Site Visit Report	Project: Taloqan Children's Park Construction
Location: Taloqan City, Takhar Province	Coordinates: Latitude: N36°44'14.886" Longitude: E 69°32'2.358"
Inspection Date: November 16, 2013	Weather: Sunny, Temp @19 C⁰ , No Precipitation
Inspectors: 	Status: Incomplete

Work Order WO-LT-0009 AMD #5

EXECUTIVE SUMMARY

Figure 8. Tt engineer measuring the height of fence panel

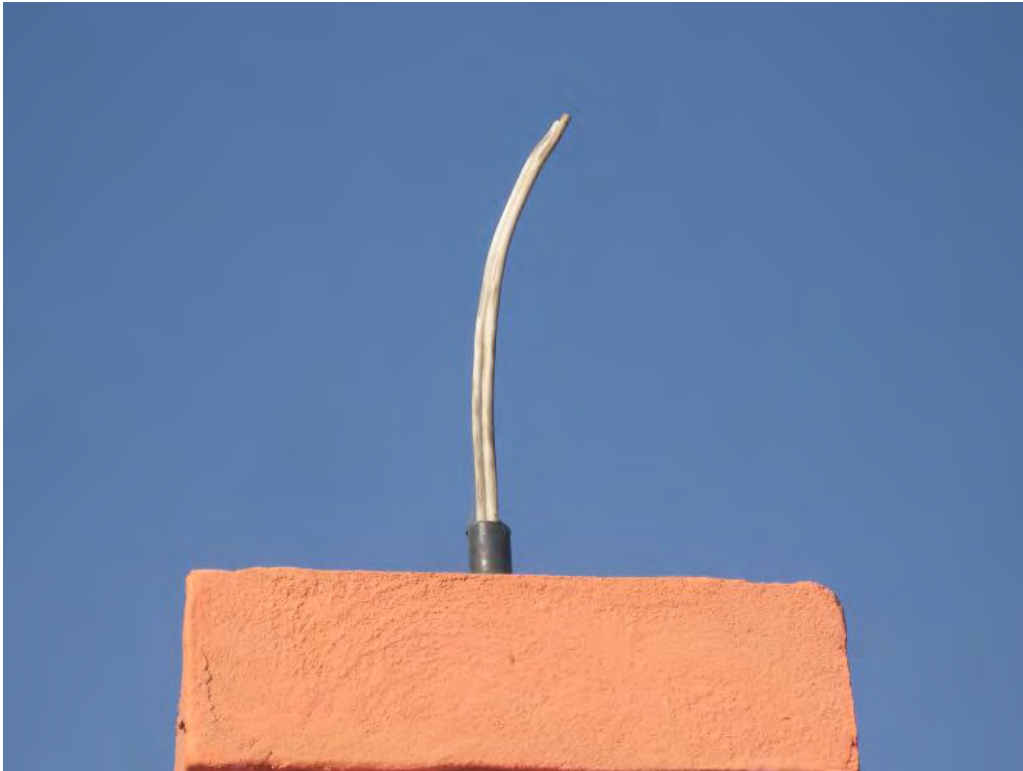
- a. **Remaining work:** Contractor is required to paint the main entrance gates with two (2) coats of anti-rust paint and two (2) coats oil paint.
2. Construction of stone masonry boundary wall with total length of 238 meters with installation of fence on the top of boundary wall is complete per plan. (Figures 4, 5, 6, 7 and 8) The lighting work for park area has not been started. (Figure 9)

- a. **Remaining work:** The contractor is required to paint the fence on top of the boundary wall with two (2) coats of anti-rust paint and two (2) coats oil paint.
